Commonwealth Edison
 One First National Plaza, Chicago, Illinois
 Address Reply to: Post Office Box 767
 Chicago, Illinois 60690

May 27, 1974

Subject: Dresden Station Unit 3 - Proposed Change to Facility Operating License DPR-25, AEC Dkt 50-249

Figure 2.1-2 Peak LHGR Versus Core Thermal Power for a Limiting Total Peaking Factor

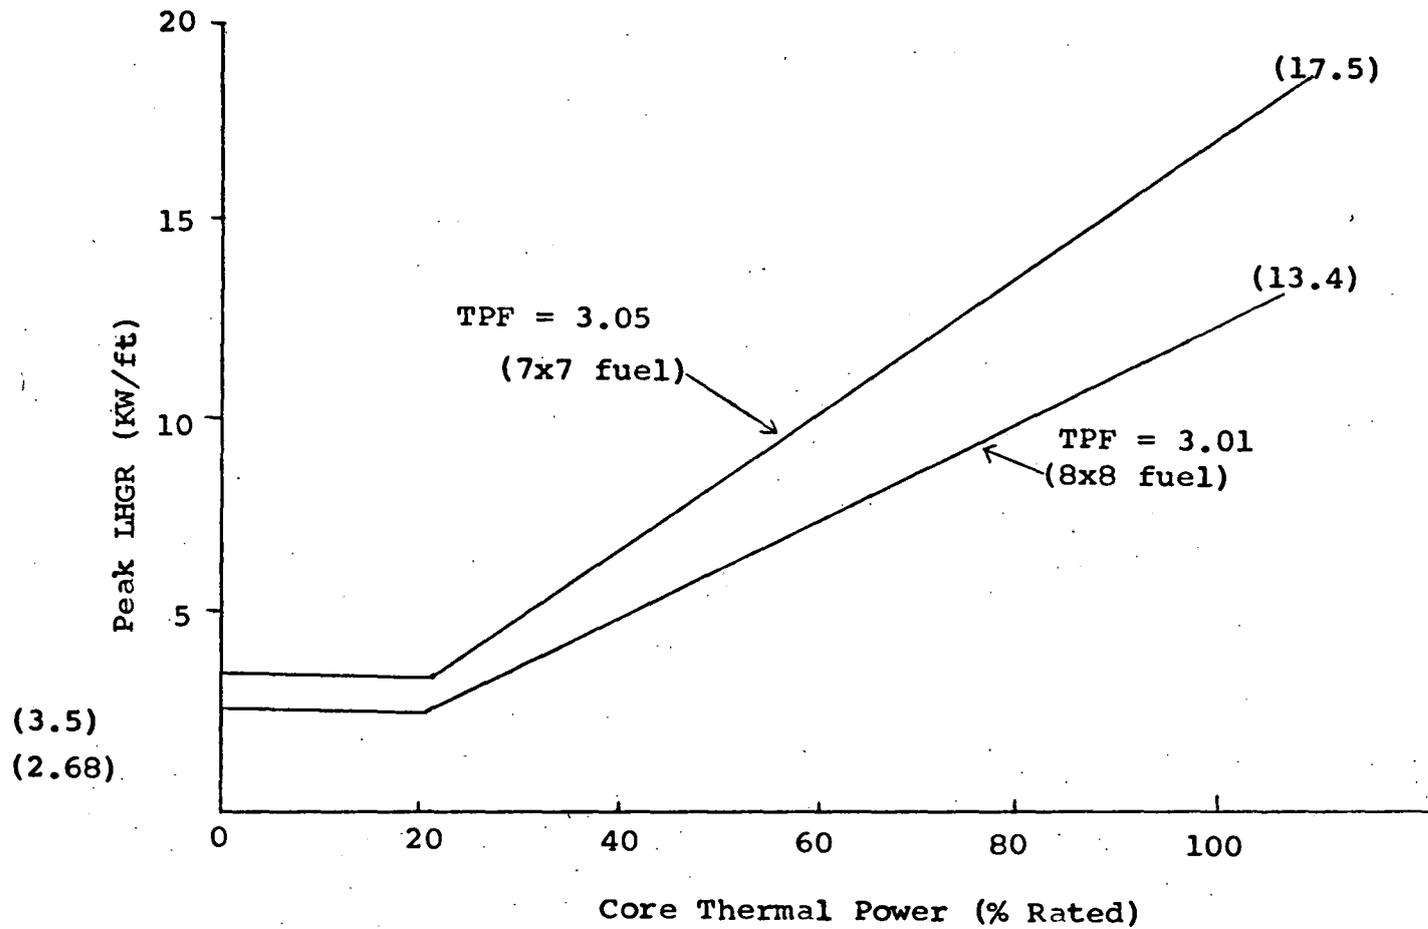
- * 1. APRM - When the reactor mode switch is in the run position, the APRM flux scram setting shall be as shown in Figure 2.1.1 unless the combination of power and peak LHGR is above the curve in Figure 2.1.2. When the combination of power and peak LHGR is above the curve in Figure 2.1.2 a scram setting(s) as given by:

TPF = LTPF unless the combination of power and peak LHGR is above the curve in Figure 2.1-2 at which point the actual peaking factor value shall be used.

- B. APRM Rod Block - The APRM rod block setting shall be as shown in Figure 2.1.1 unless the combination of power and peak LHGR is above the curve in Figure 2.1.2. When the combination of power and peak LHGR is above the curve in Figure 2.1.2 a rod block trip setting (SRB) as given by:

$$S \leq .65W + [55] \left[\frac{LTPF}{TPF} \right]$$

$$SRB \leq .65W + [43] \left[\frac{LTPF}{TPF} \right]$$
